# CITY OF ALBUQUERQUE

March 24, 2023

**RE: 1560 Juan Tabo Blvd. NE**  
**Grading and Drainage Plan**  
**Engineer's Stamp Date: 03/14/23**  
**Hydrology File: J22D044**

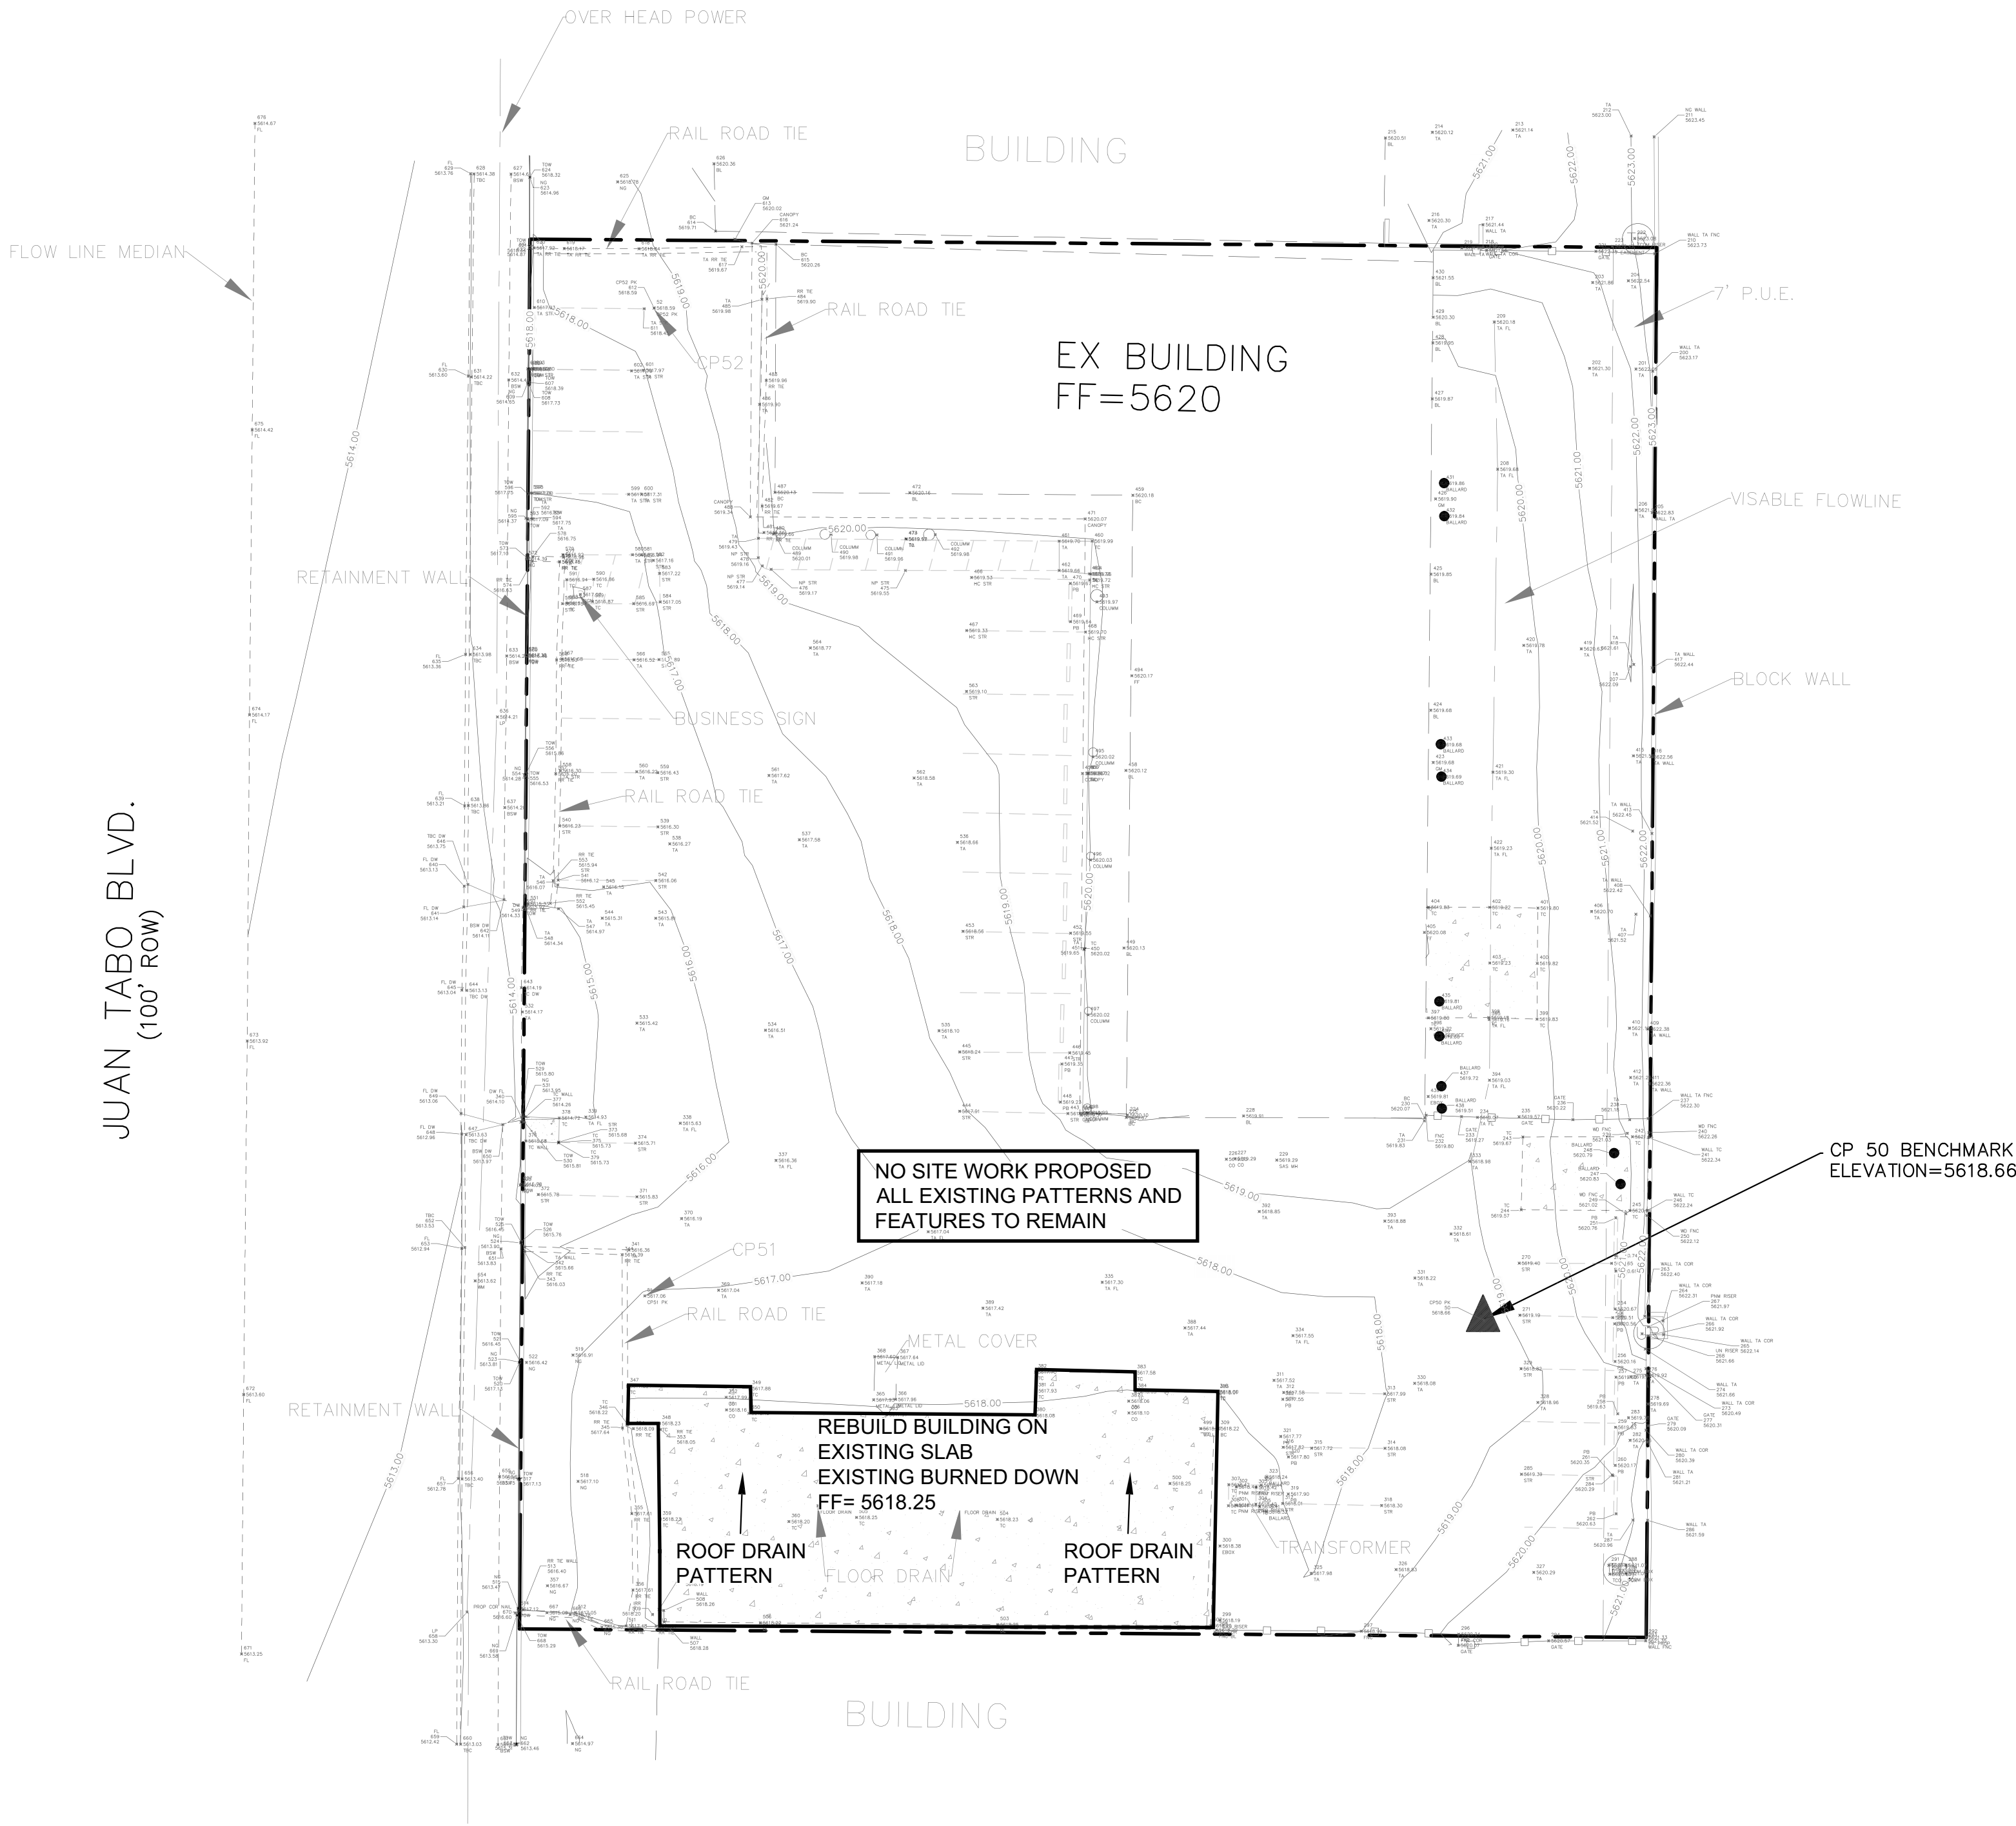
Based upon the information provided in your submittal received 03/15/2023, the Grading & Drainage Plan is approved for Building Permit. Please attach a copy of this approved plan in the construction sets for Building Permit processing along with a copy of this letter.

1. Engineer's Certification, per the DPM Part 6-14 (F): *Engineer's Certification Checklist For Non-Subdivision* is required.
2. Please pay the Payment-in-Lieu of \$ **580.67** by emailing the attached approved Waiver Application from Stormwater Quality Volume Management On-site to [PLNDRS@cabq.gov](mailto:PLNDRS@cabq.gov). Once this is received, a receipt will then produce and email back. Follow the instructions on the bottom of the form and pay it at the Treasury next to Building Permits. Once paid, please email me proof of payment.
